WRITTEN COMMENTS AND RESPONSES

Subject: PG&E Application to Sell Generating Plants (#98-01-008)
SCH #: 98082013

RE: California Energy Commission Comments of the CPUC's Draft Environmental Impact Report for Application 98-01-008, Pacific Gas and Electric Company's Application for Authorization to Sell Certain Generating Plants and Related Assets

**FIGURE N5-1
COMPARISON OF PG&E GEYSERS GEOTHERMAL FORECASTS
(CEC Electricity Reports vs. Historic Data)**

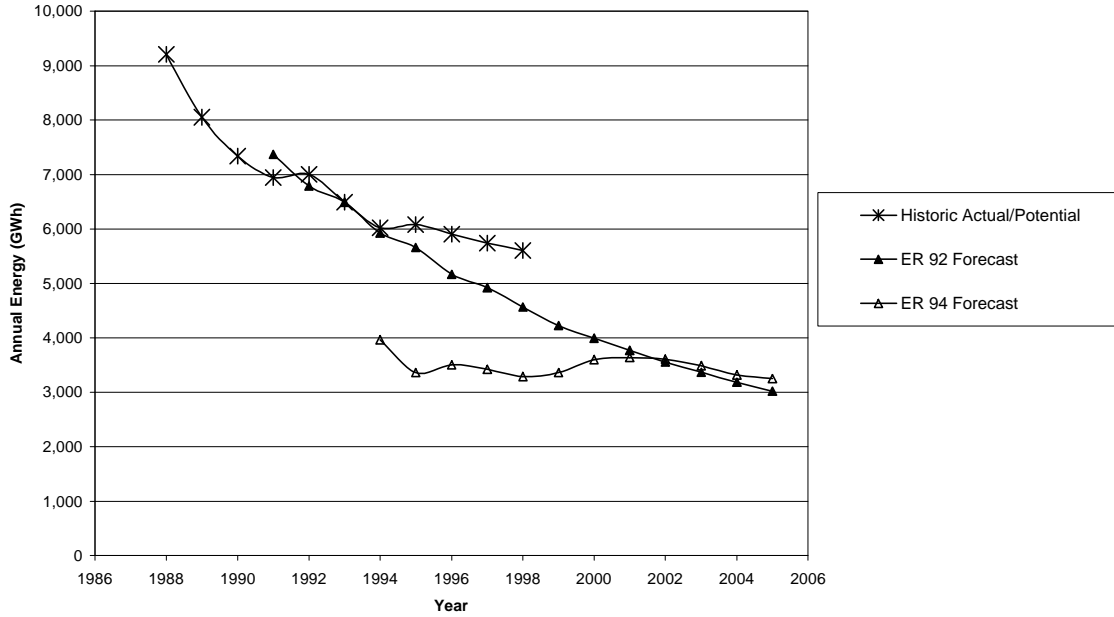
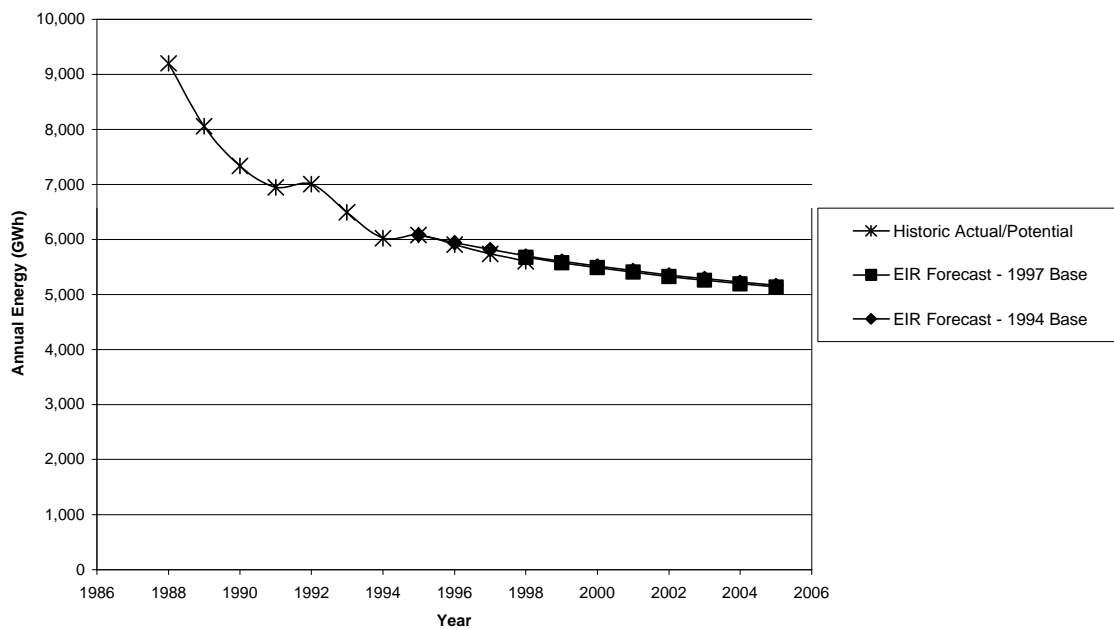
The 1992 and 1994 CEC Electricity Report forecasts for Geysers generation were found by analysis to be outdated. Figure N5-1 compares historic actual or available (when curtailed) generation through 1998. It is immediately obvious that the Geysers steam resource is not declining as rapidly as forecast in 1992 and 1994. PG&E’s *Report on Reasonableness of Operations for 1997* discusses the many reasons for this dramatic change in the decline. For this reason, a new forecast was developed.

Addressing the commenter's recommendation to use megawatt-hours instead of percentages, please see the response to Comment N6.
